**SOUTH CAROLINA BUILDING CODES
STATEWIDE MODIFICATIONS INDEX**

2012 INTERNATIONAL RESIDENTIAL CODE

**SOUTH CAROLINA MODIFICATIONS
TO THE 2012 EDITION OF THE
INTERNATIONAL RESIDENTIAL CODE**

FIGURE 307.2
MINIMUM FIXTURE CLEARANCES

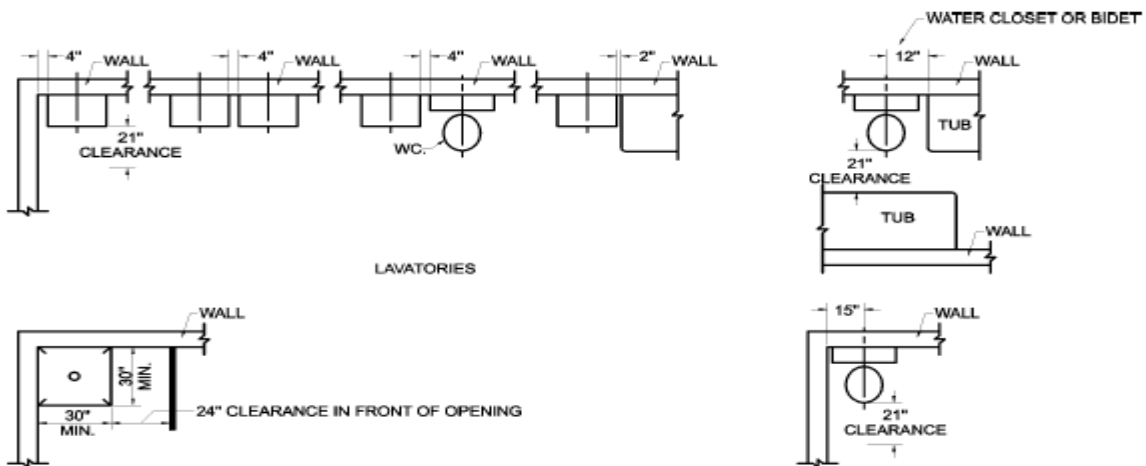
Modification Number: IRC 2012 06.

Figure: R307.1 Minimum Fixture Clearances.

Modification: Change the minimum dimension for the side clearance between bathtubs and water closets and bidets from 15 inches to 12 inches.

Reason: No valid reason exists to justify a minimum clearance of 15 inches.

Notes: Continued modification IRC 2003 05 and IRC 2006 06. The Figure number changed from 307.2 to 307.1 in the 2012 IRC.
